UNITED STATES PATENT AND TRADEMARK OFFICE

Office Action Summary	Application No. 10/614,532	Applicant(s) MCFADDEN, DAVID H.	
	Examiner Sarah Suereth	Art Unit 3749

DETAILED ACTION

Segment of Fig. 8 of Smith
(the examiner has added lead arrow and text)

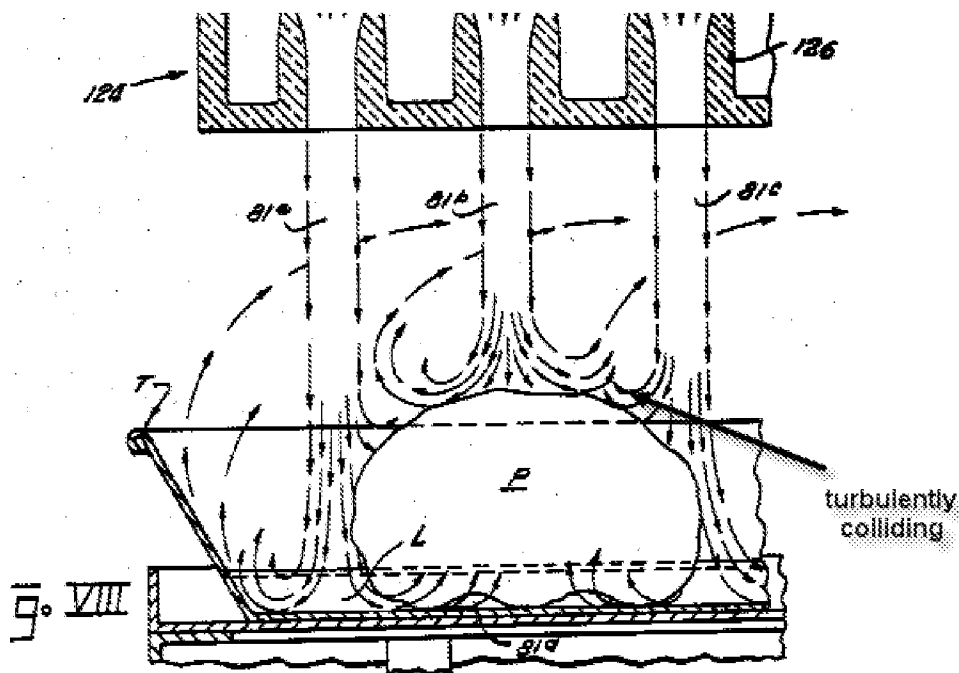
In particular, in regard to at least claim 95, Smith shows a system and method of speed cooking a food product with gas comprising the steps of: providing a housing (1) defining an oven cavity (formed by 2',4',6' and 8'), providing a first means (any one of 80, Figs. 2 and 3 or 124, Fig. 8) for directing gas within the cooking chamber and a second means (any other adjacent nozzle/opening 80, Figs. 2 and 3 or 124, Fig. 8). Each of openings (80 or 124) is disposed above the food product for directing gas

above the food product. Gas from the openings is provided in the form of jets (81). As shown particular in Fig. 8, a first gas jet (81b) and a second gas jet (81c) are provided to strike a food product (P) and are considered to collide turbulently in close proximity to a surface of the food product to desirably enable “very rapid heat transfer and very rapid water vapor removal from the surface of the product” (see col. 10, lines 45-51). The following is a segment of Fig. 8 of Smith to further illustrate what the examiner considers to be “turbulently colliding” gas flows:

Further, the examiner notes that Smith expressly describes that jets (81), when striking a solid surface will be transformed, into a “turbulent mushroom shaped pressure area” (see col. 11, lines 6-11). While this discussion is in the context of the jets striking

the bottom of the food product, the examiner considers that a person of ordinary skill in the art would recognize that the “turbulent mushroom shaped pressure area” would also result on the top of the food product (as shown for instance in Fig. 8 of Smith).
